UNITED STATES PATENT AND TRADEMARK OFFICE

APPLICATION NO.	FILING DATE	FIRST NAMED INVENTOR	ATTORNEY DOCKET NO.	CONFIRMATION NO.
10/730,141	12/09/2003	Yasunori Suzuki	246359US8	5899

Office Action Summary

DETAILED ACTION

Insert 1: US Patent No. 6,549,067 to Kenington, figure 1

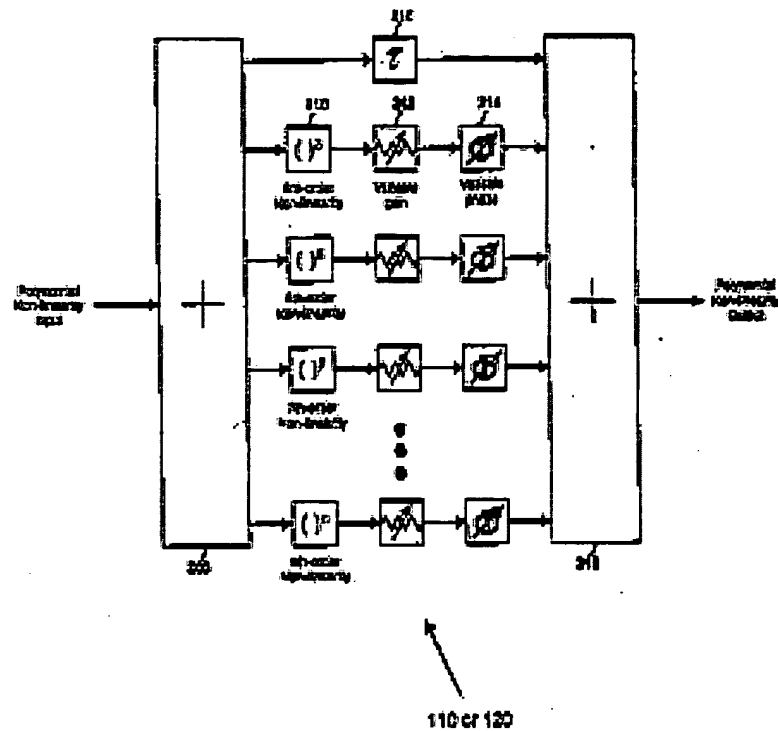
4. Regarding claims 1, 5, 7-2, 8, 26, 28, 32 and 33, Kenington discloses a method and apparatus for linearizing an output signal. Kenington discloses a system comprising a DSP (100), which takes in in-phase and quadrature channels and separately, digitally predistorts (110 and 120; also see column 3, lines 1-8 and column 2, lines 6-18) them and then up-converts them to IF (122, 124, 126, 128). The IF signal is the sent through a DAC (130; also see column 3, lines 8-11) and up-converted to RF before amplification (132, 134, 136, 138 also see column 3, lines 11-23) by the power amplifier (140; also see column 3, lines 14-21 and 24-36). The pre-distorters are adapted using feedback supplied to the DSP (100) from the output of the amplifier from a splitter (142). The feedback signal is down-converted (136, 144, 146, 148; also see

column 3, lines 29-36) and sent through an ADC (148) before being coupled to the DSP (100) to update the predistorter (see column 3, lines 24-36). The system could also be modified to use a pilot signal, subject to cross modulation from the input signal during the up-conversion and the amplification process, which is created within the DSP (100) and added prior to up-conversion to IF (see column 6, line 61- column 7, line 8).

Insert 2: US Patent No. 6,549,067 to Kenington, figure 2

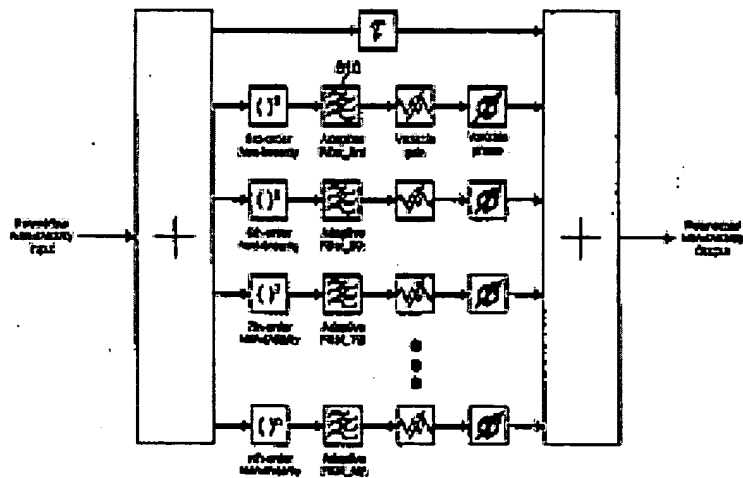
5. Regarding claim 2, 6-2, 10-2, 14, 15, 18 and 25, Kenington discloses digital pre-distorters (110 and 120) provides the input signal to a splitter where it is distributed to various components to generate various orders of distortion where the gain (212) and phase (214) are adjusted before the signal is supplied to a combiner (216). The basic predistortion scheme can be adjusted using an adaptive filter (610). The adjusted signals are recombined with the input signal after being delayed (218) and then input to a mixer (See figure 2 and corresponding text; figure 6 and corresponding text; column 6, line 61- column 7, line 8; and column 3, line 57- column 4, line 3).
